BOARD OF ZONING APPEALS DIVISION III

Case Number: 2025-DV3-010 (2nd Amended)
Address: 909 Wright Street (approximate address)
Location: Center Township, Council District #18
Zoning: D-8 (TOD) (RC)
Petitioner: 8424 Bravestone LLC, by Mark & Kim Crouch
Request: Variance of Development Standards of the Consolidated Zoning and Subdivision Ordinance to provide for the construction of a single-family dwelling with a three-foot south side yard setback (five-feet required), a three-foot rear yard setback (20 feet required), an open space of 30 percent (40 percent required) and a front-loaded carport.

Staff Recommendation: Staff recommends denial of this petition.

Site Plan - 2nd Amended April 26, 2025

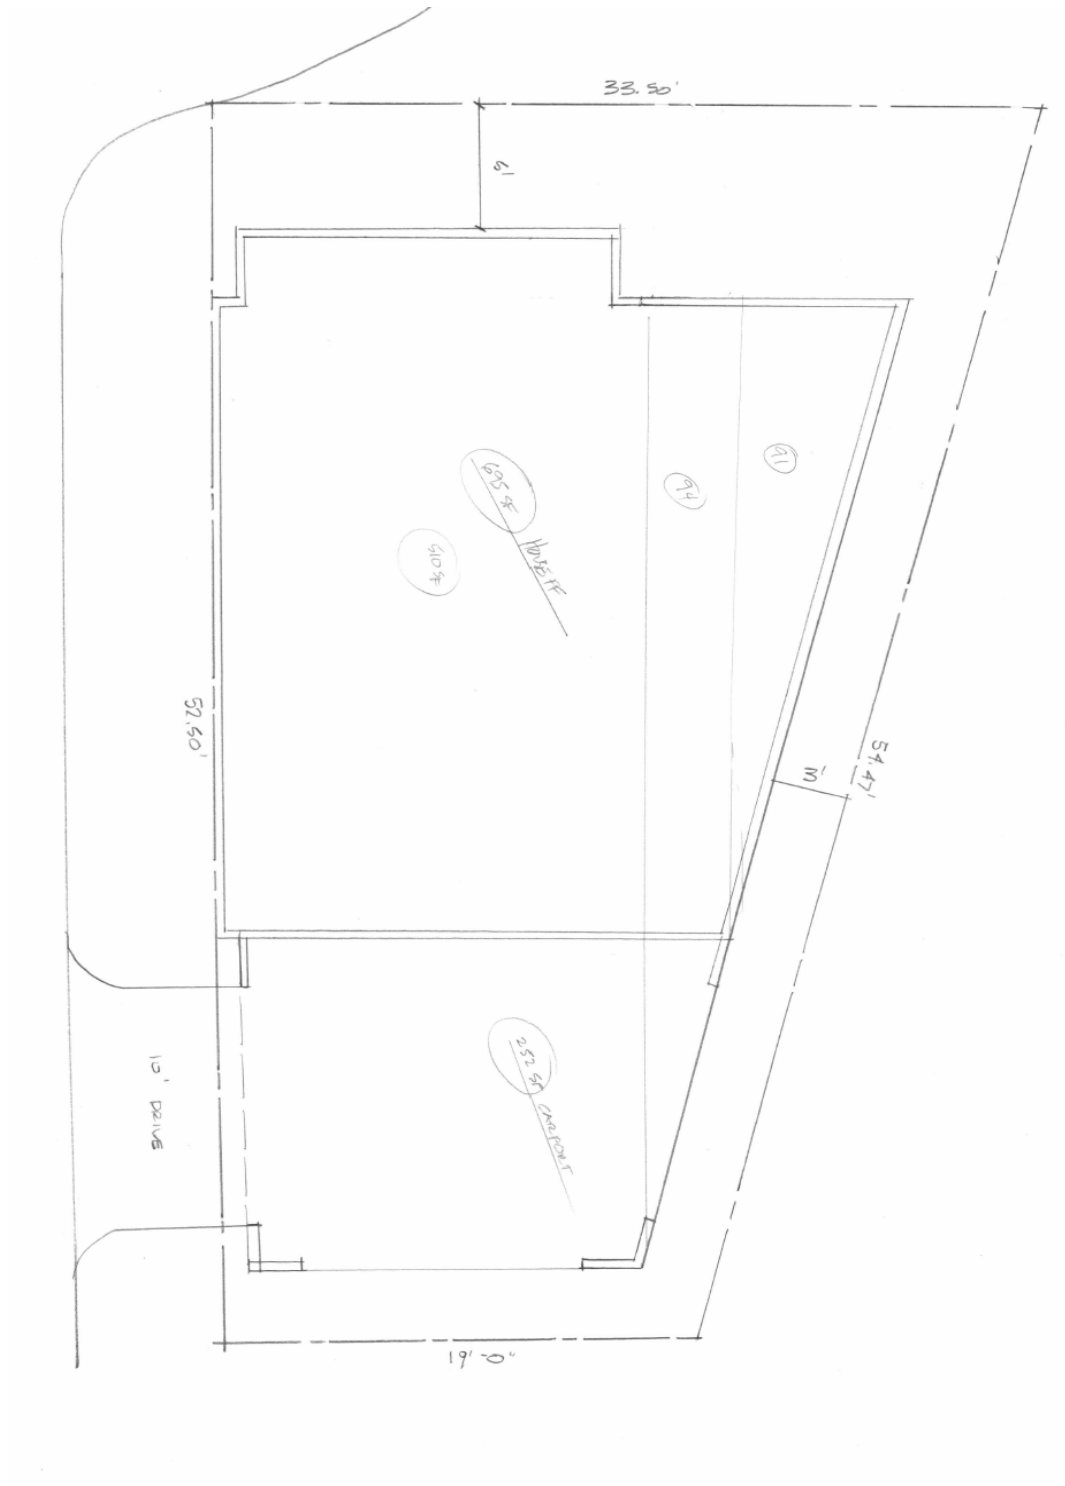
- ◇ Under Table 744-701-2, the subject site would fall under the Terrace Frontage category for Private Frontage Design Standards. The subject site is in a neighborhood where the context of the block establishes smaller frontages as the predominant pattern (typically 50% or more on the block face or at transitions to adjacent blocks and frontages). Table 744-701-2 describes Front Loaded Garage Placement and Limitations, where it stipulates front loaded garages are prohibited. Side loaded, rear loaded, or detached garages are the only garages permitted.

- ◇ The proposed site plan displays that the subject site has access to the cul-de-sac at the north end of the property. However, the proposed garage / carport access would be directly from Wright Street. Staff concludes the desire not to use the cul-de-sac for a side load garage is to be a self-imposed practical difficulty. The site plan could be reconfigured with an attached garage at the north end of the parcel. If the plan were reconfigured to reflect this, it would eliminate the need for a front-loaded garage variance.

- The findings submitted by the applicant for this petition indicate that the proposed residence and attached garage will be consistent with the development in the area and adjacent area. Staff disagrees in that the majority if not all houses in the area have detached garages. Even if the garage remains attached, it can be accessed from the side of the dwelling from the cul-de-sac to the north. Placing the front-loaded garage massing to the side, instead of in front of the dwelling, would actually make the proposed garage consistent with the development in the area, as the majority are to the rear of their respective dwellings. Therefore, any restrictions on garage placement is self-imposed by their desire not to have a side loaded garage.

- ◇ Given the close proximity of other developed properties without front loaded garages, staff does believe this would be a significant deviation from the Ordinance and would negatively impact the character of development within the surrounding area, and would therefore, not be supportable.
